**Amendments to the Drawings:**

Serial No.: 10/619,676

**APPENDIX A**

## Annotated Marked-up Drawings

FIG. 5

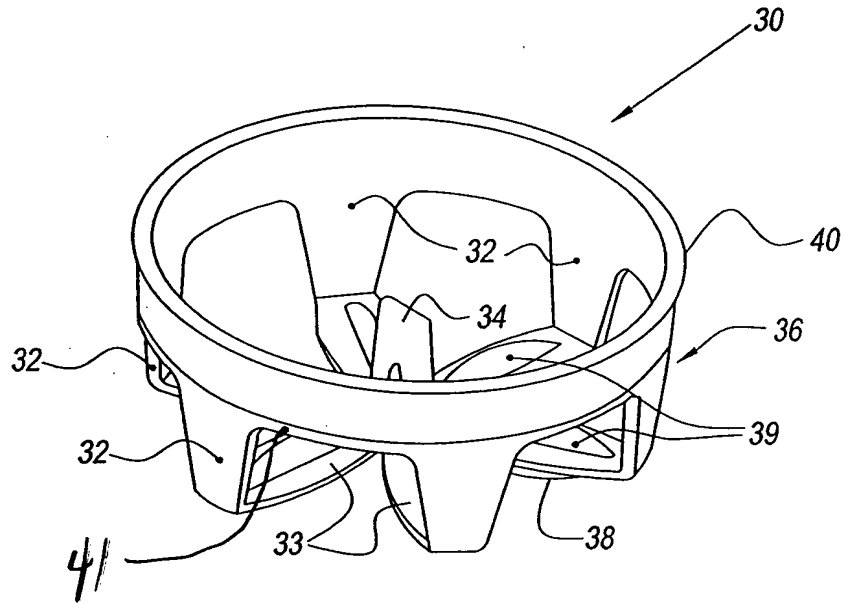
FIGS. 5 and 6 have been corrected to add reference numeral "41" as discussed and agreed to by the Examiner in the interview of August 25, 2004. Attached in Appendix A are the marked-up drawings with red-ink annotations for approval by the Examiner, and a clean copy including the proposed corrections. Previously approved corrections from Applicant's March 31, 2004 Amendment are also included.

The Office Action objects to the drawings asserting that there is an omitted feature. Proposed corrections have been made to FIGS. 5 and 6 to include reference numeral 41 for the tapered portion which is clearly shown in the drawings, including FIGS. 5 and 6, as agreed by the Examiner in the telephone interview.
